**From:** [Cuevas, Lawrence \(DPW\)](#)  
**To:** [Froehlich, David \(DPW\)](#); [Sprinkle, John \(DPW\)](#)  
**Subject:** RE: Hairball Project  
**Date:** Thursday, November 30, 2017 3:16:01 PM

**From:** Froehlich, David (DPW)  
**Sent:** Tuesday, November 28, 2017 4:02 PM  
**To:** Cuevas, Lawrence (DPW) <[lawrence.cuevas@sfdpw.org](mailto:lawrence.cuevas@sfdpw.org)>; Sprinkle, John (DPW) <[John.Sprinkle@sfdpw.org](mailto:John.Sprinkle@sfdpw.org)>  
**Subject:** FW: Hairball Project

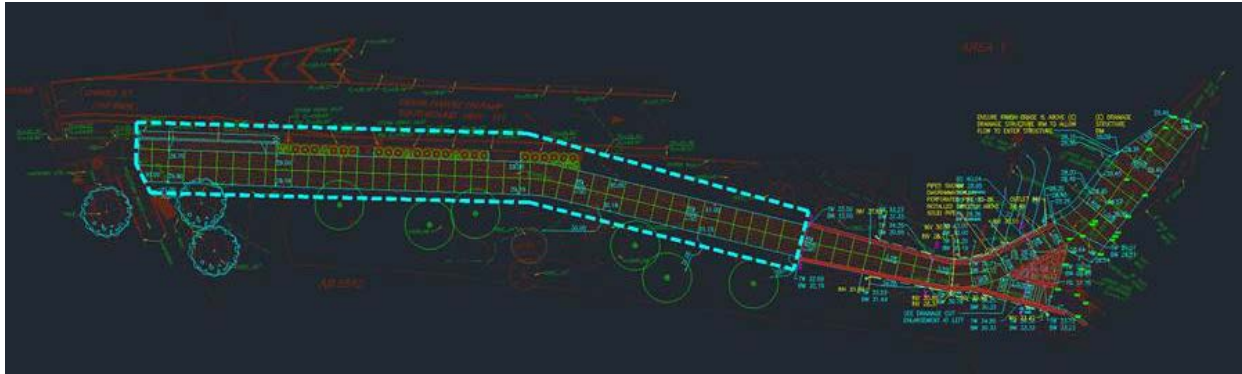
- remove planting and use boulders?
- add trees to large lot if we can afford 3 year maintenance (she suggested something showy like Horsechestnut or something native like buckeye)
- Do we need to add skatestops?
- increase concrete thickness for vehicular load

- I agree with removing planting in the sloped triangular area near the ramp. I'd suggest we replace this with riprap considering the slope. Would you also like us to remove the planting at the 3' buffer and replace with boulders?
- I've added six buckeyes south of the path
- I'll add skatestops to handrails, and a "notched" skatestop detail for the walls (John, we can coordinate).
- We'd like to clarify the vehicular access-- we recommend only accommodating vehicles on the western side of the project, and not anything within the retaining walls or beyond in the area under the on ramp. This seems to be in line with the current loop that vehicles make in this area. If you agree we can show a 6" concrete path in the part of the path outlined with a dash below, and 4" everywhere else:
